RECORD OF DECISION

**Kentucky Avenue Wellfield Superfund Site
Operable Unit 4 – Koppers Pond
Chemung County, New York**

**United States Environmental Protection Agency
Region 2
New York, New York
September 2016**

Photo #5- Looking North

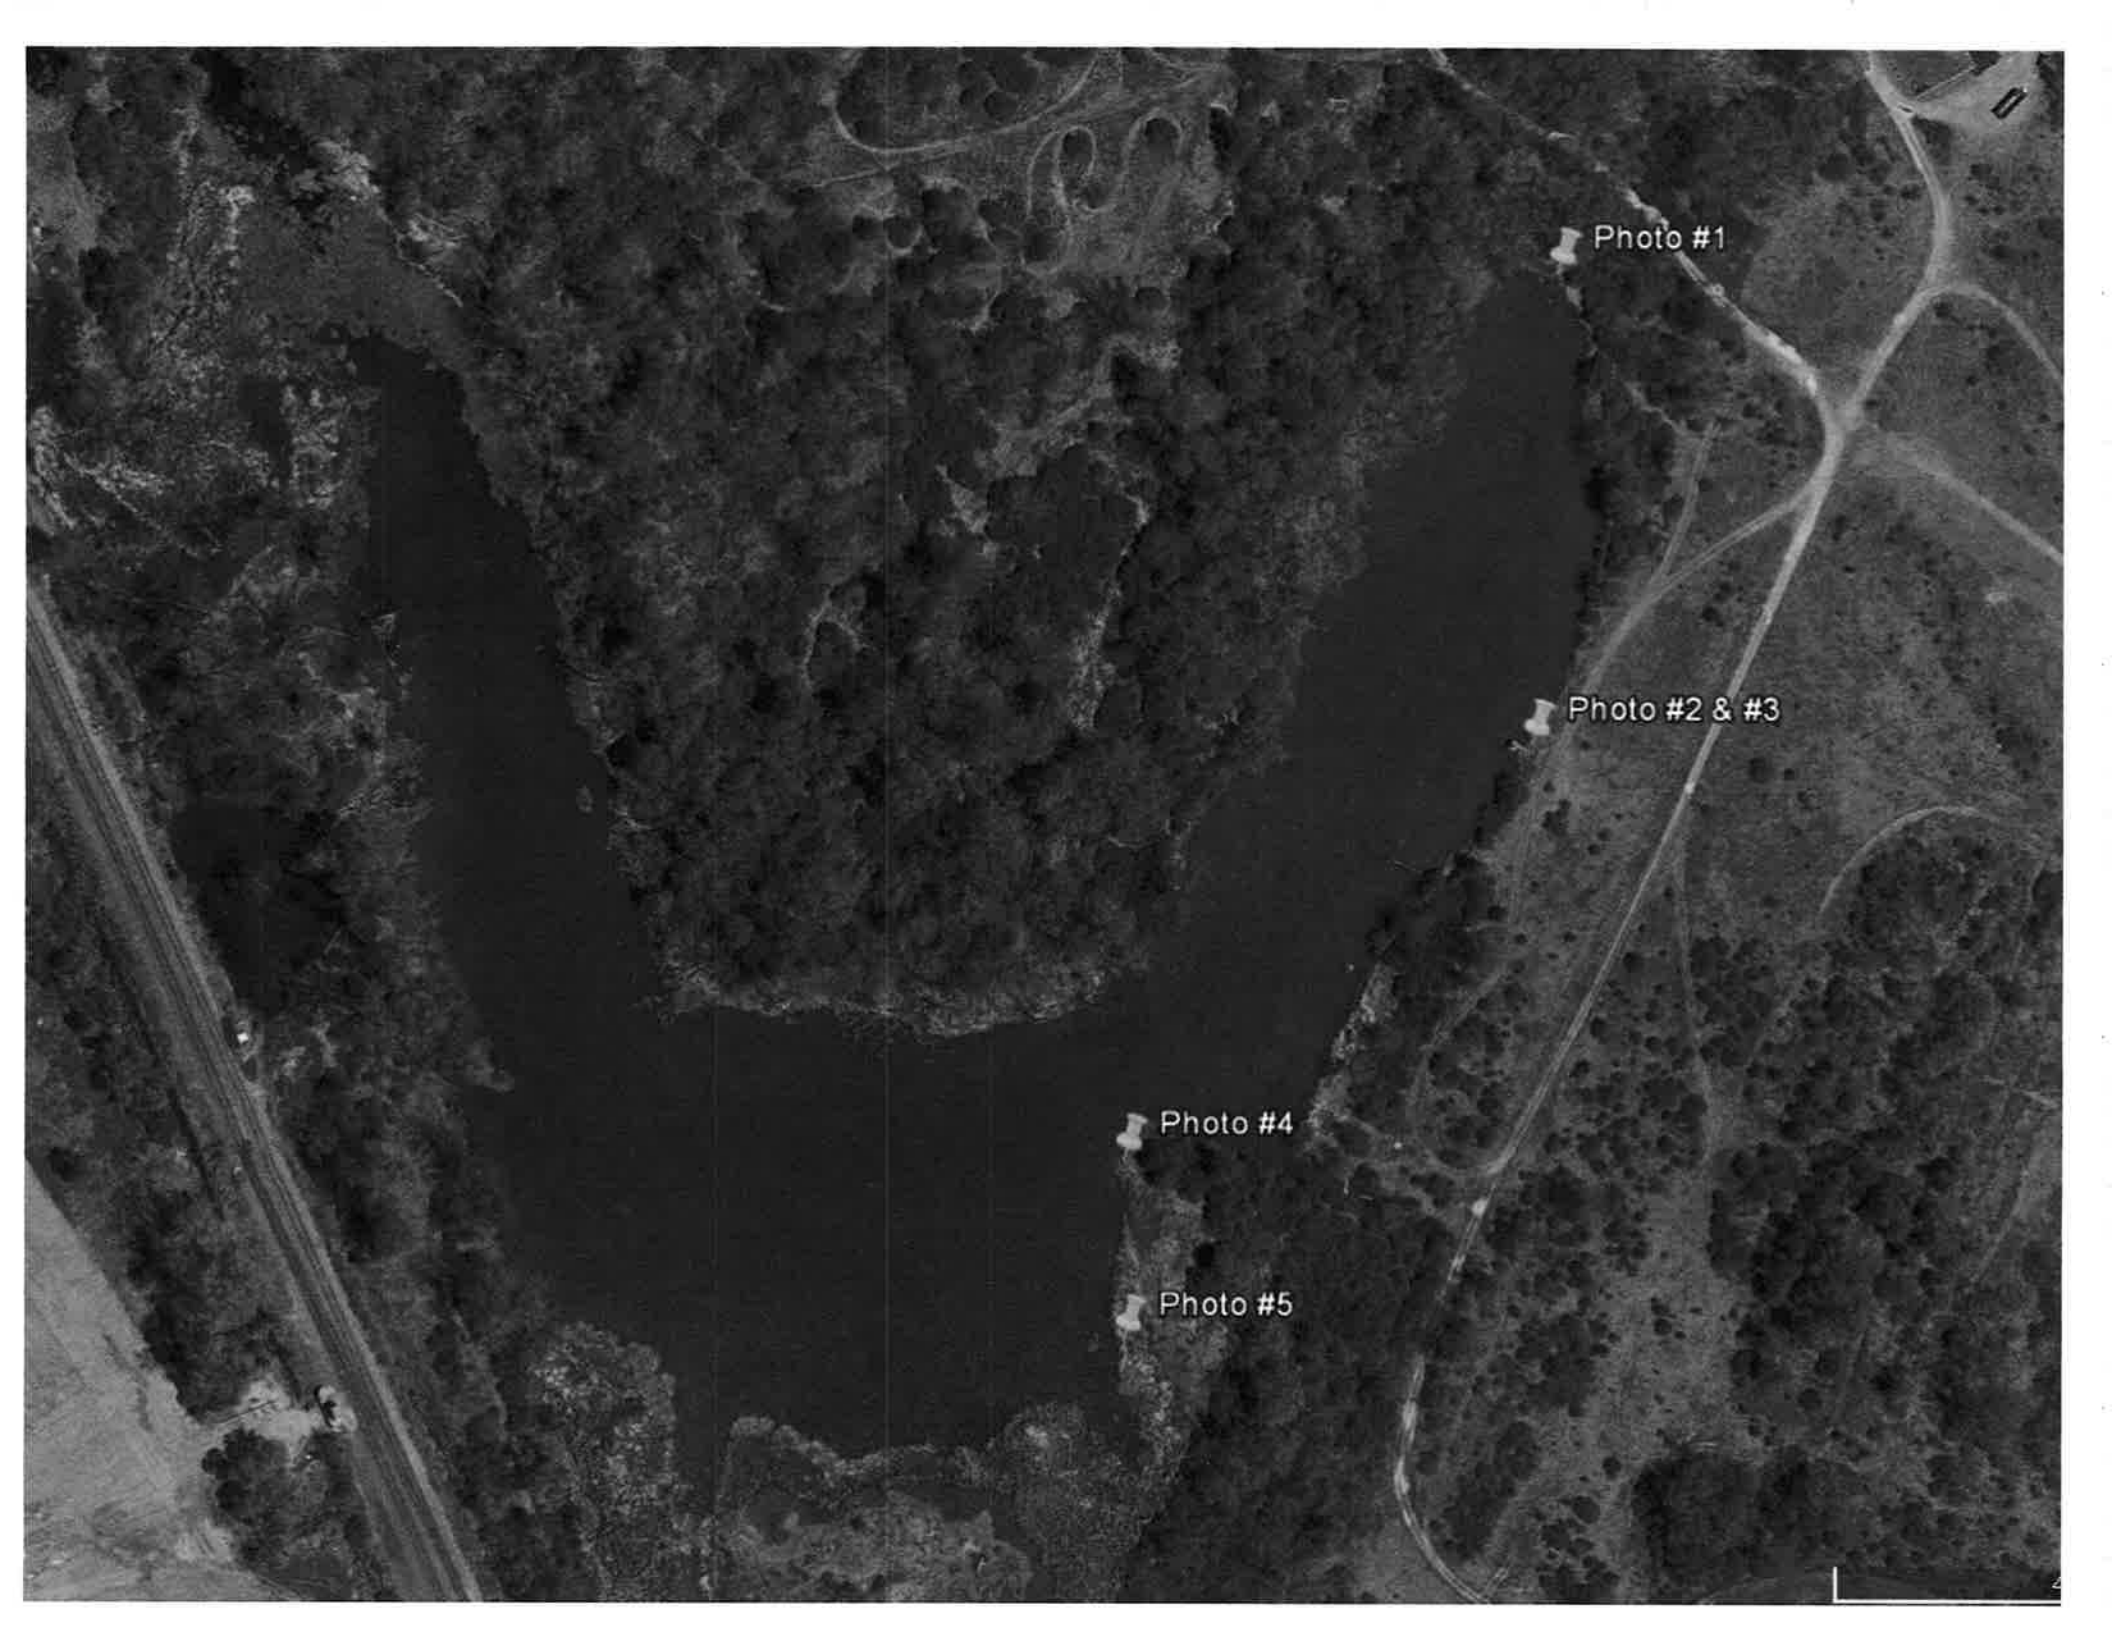
Comment # 1: CBS Corporation (CBS) and Beazer East, Inc. (Beazer) commented that EPA's selected remedy should not include measures meant to address or mitigate against fish consumption, since no visible fish population currently exists or will exist in the future at Koppers Pond. The commenters state that the only scenario whereby Koppers Pond would return to open water and support a fish population again would be through artificial means, such as the discharge of large quantities of water, over a long period of time, from the groundwater extraction and treatment plant located at the former Westinghouse facility and the restocking of the resulting pond. The comment further states that the treatment plant, which was constructed pursuant to the Record of Decision issued by EPA to address groundwater contamination at the Site, has been shut down since April 2014 and renewed operation is unlikely. CBS, as the party that implemented the groundwater remedy, states in the comment that it believes that the requirements of the OU2 Record of Decision addressing groundwater contamination at the Site have been fulfilled and that groundwater conditions at the former Westinghouse facility no longer require or justify operation of the extraction and treatment system. The commenters note that a recent substantial rainfall in the Koppers Pond area, and the resulting storm water discharge to the pond, resulted in little to no change in the pond hydrology. The commenters provide recent photographs showing the absence of an open water area and vegetation covering the pond.

Response to Comment #1: Consistent with EPA's guidance for conducting risk assessments to support remedy selection decisions, the human health risk assessment evaluated cancer risks and noncancer hazards under current and future conditions. As indicated in the Proposed Plan, under current hydrologic conditions in the pond, exposures to the pond including the ingestion of fish are not complete pathways. Furthermore, the Proposed Plan states that a July 2016 inspection of the pond revealed that the pond did not have any open water. However, resumption of the treatment system discharge or other significant discharges to the industrial drainageway could restore conditions that would once again support a fish population. As discussed in the HHRA, the cancer risk range and the goal of protection of an HI=1 were exceeded under potential future conditions.
